Service Bulletin: SB407-300; Bell 407 Air Conditioner Drive Pulley Bevel Washer Replacement.

Subject: Tail Rotor Driveshaft Bevel Washer Replacement.

Date: 15 April, 2004

Applicability: Bell Helicopter Model 407 series equipped with the Air Comm Corporation air conditioner system.

Figure 1 Original Compressor Drive Sleeve Installed;
 S/N 53000 to 53319

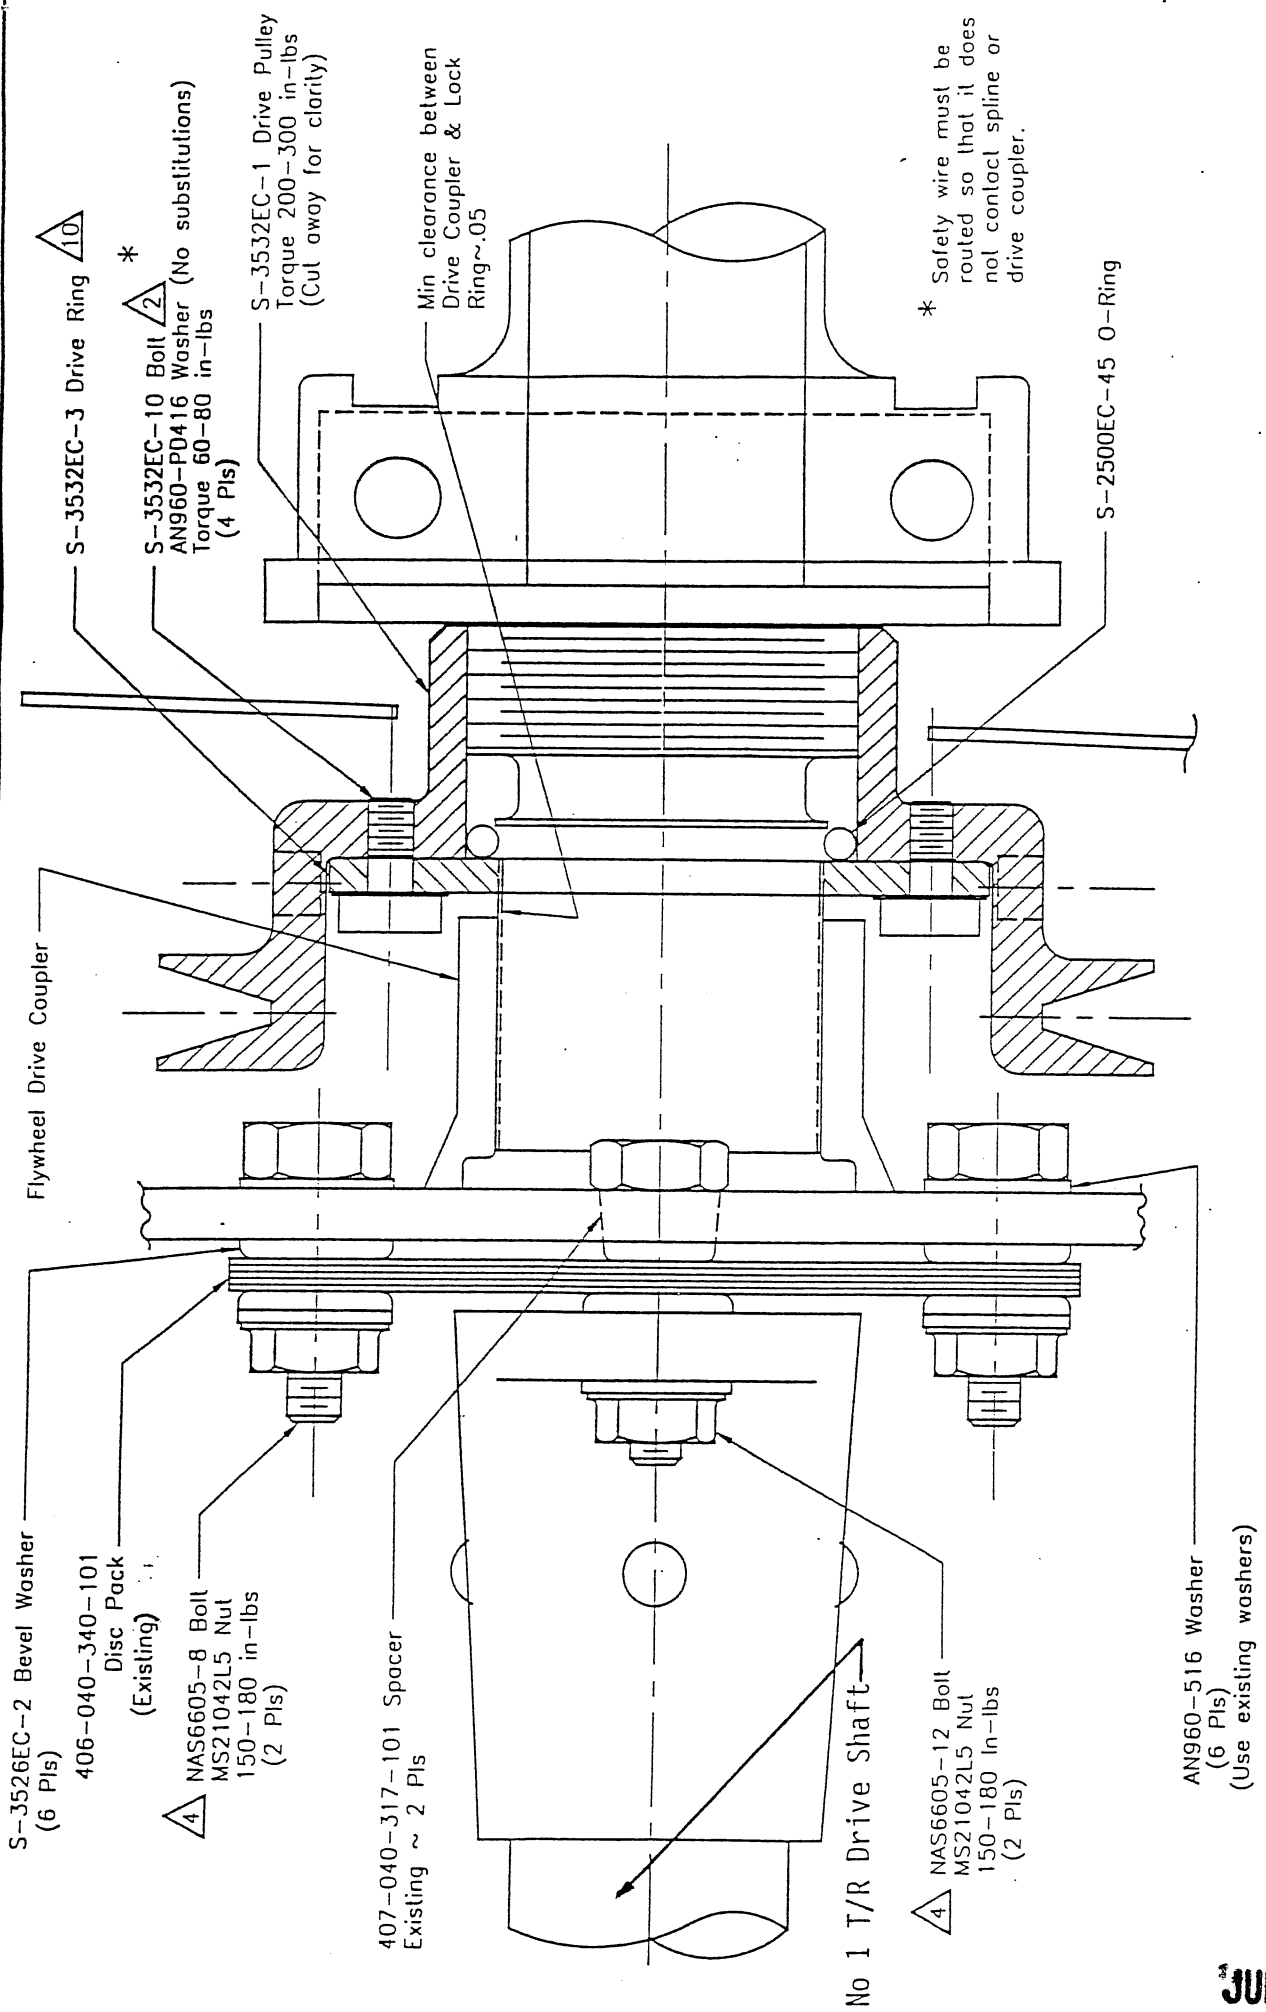
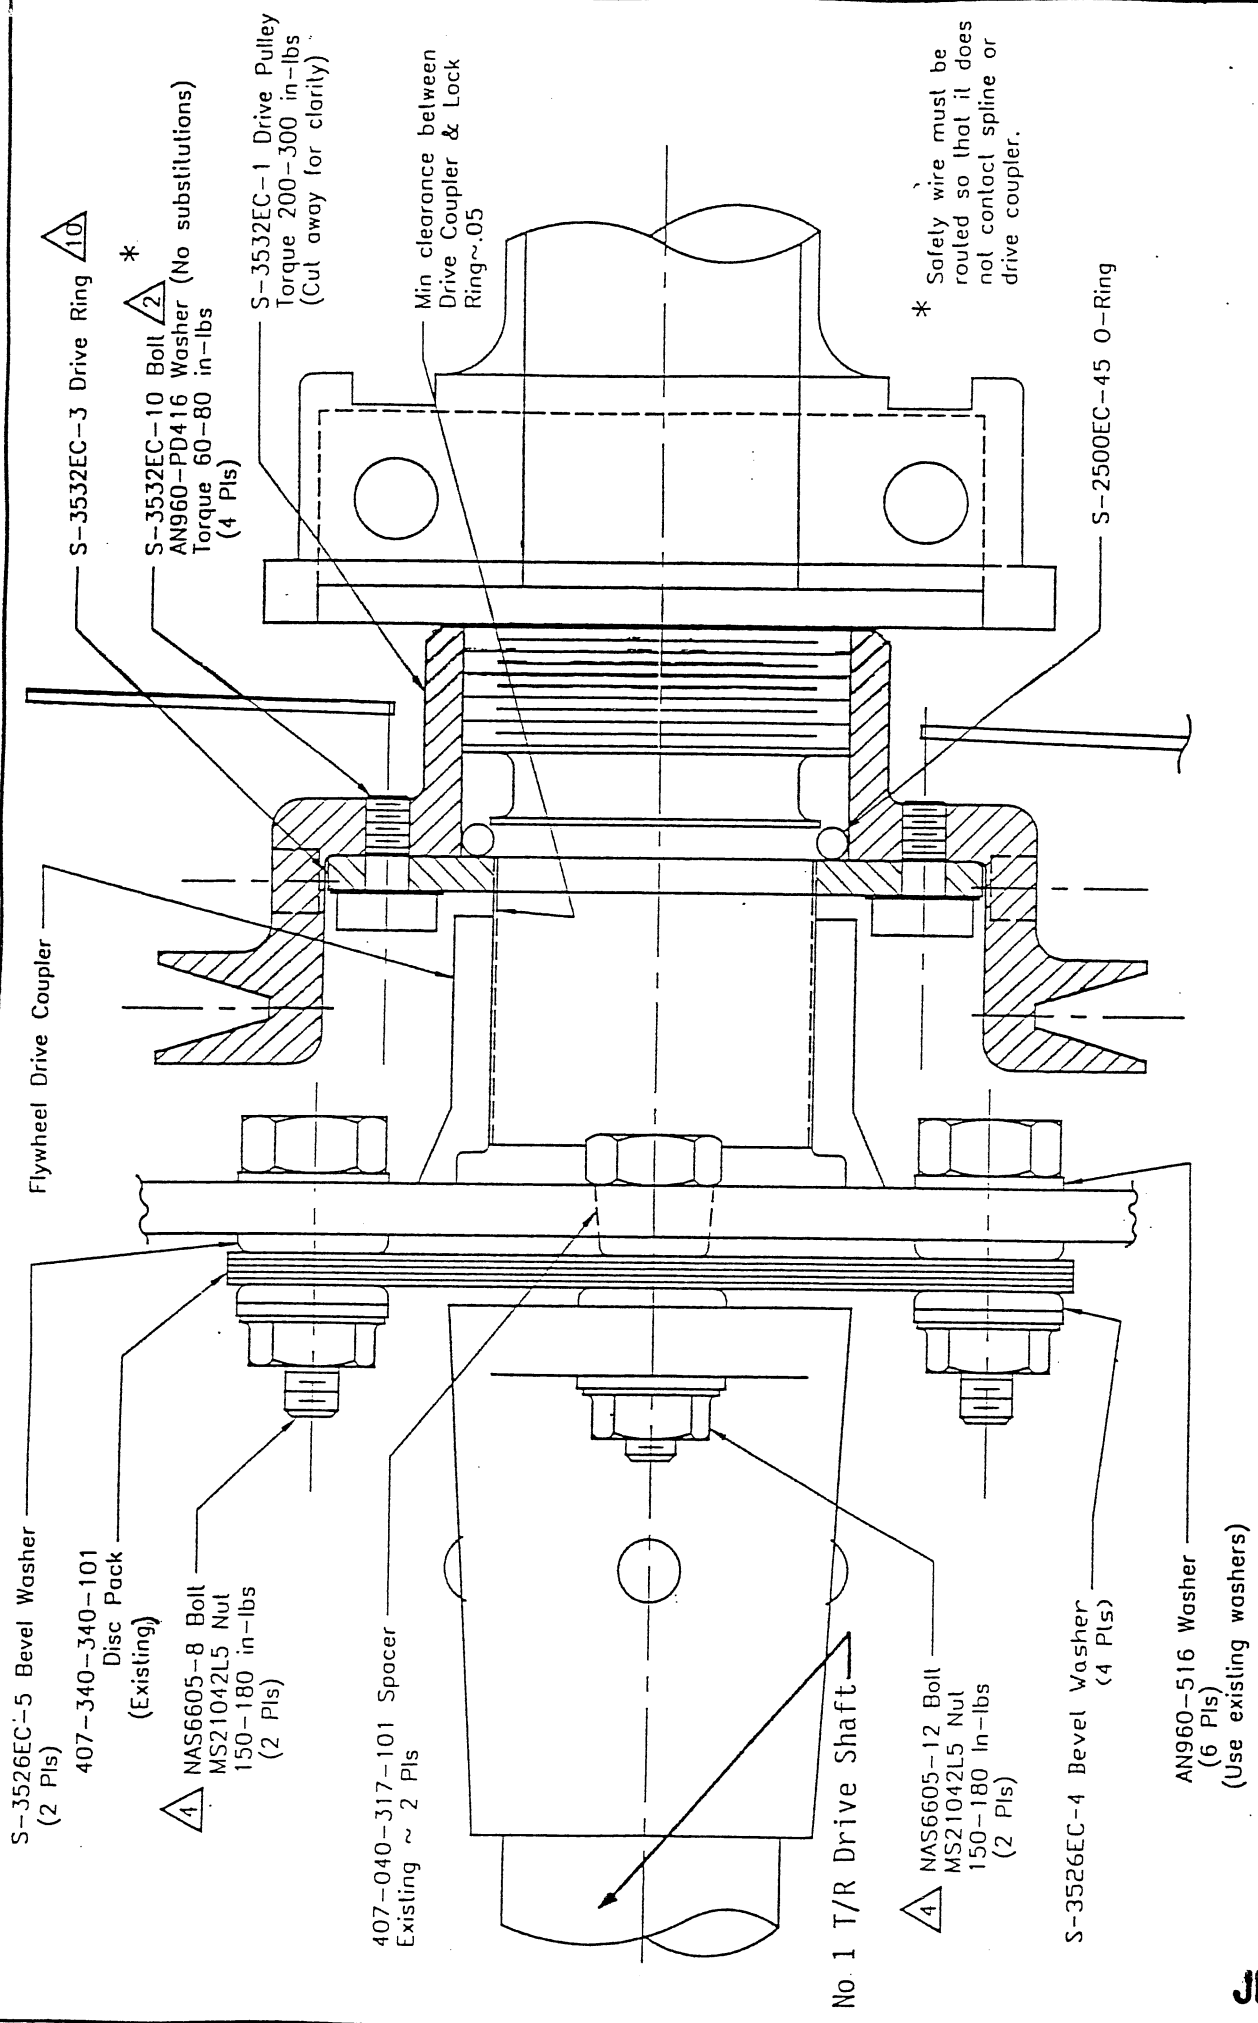
Due to the implementation of TB407-99-18, it has become necessary to replace the tail rotor drive shaft Bevel Washers (S-3526EC-2) located between the Tail Rotor Flywheel assembly and the Driveshaft Coupling Disc Pack.

It has come to our attention that contact between the new Disc Pack and the flywheel can occur on aircraft equipped with the Air Comm Air Conditioner. This has shown to result in slight scouring of the flywheel hub.

This bulletin provides instructions for installation of new bevel washers. The effect of this change is to increase the spacing between the disc pack and the flywheel by .021 inches. The location of the drive coupler is unchanged.

1. Remove mounting hardware for Disc Pack P/N 406-040-340-101, which includes washers P/N S-3526EC-2 (.055 thick). Upon removal of Disc Pack, discard washers (6 each).
2. Installation of new Disc Pack P/N 407-340-340-101 includes washers P/N S-3526EC-4 (4 each) and washers P/N S-3526EC-5 (2 each). When installing the new disc pack, install washers (P/N S-3526EC-4) between the existing washer P/N AN960-516 (existing washer is against the nut) and disk pack on all 4 mounting bolts. Install washers (P/N S-3526EC-5) on 2 mounting bolts, between disk pack and flywheel.
3. Torque application is: torque on nuts must be minimum of the run-on-tare torque plus 150 inch-lbs to a maximum of the run-on-tare torque plus 180 inch-lbs.
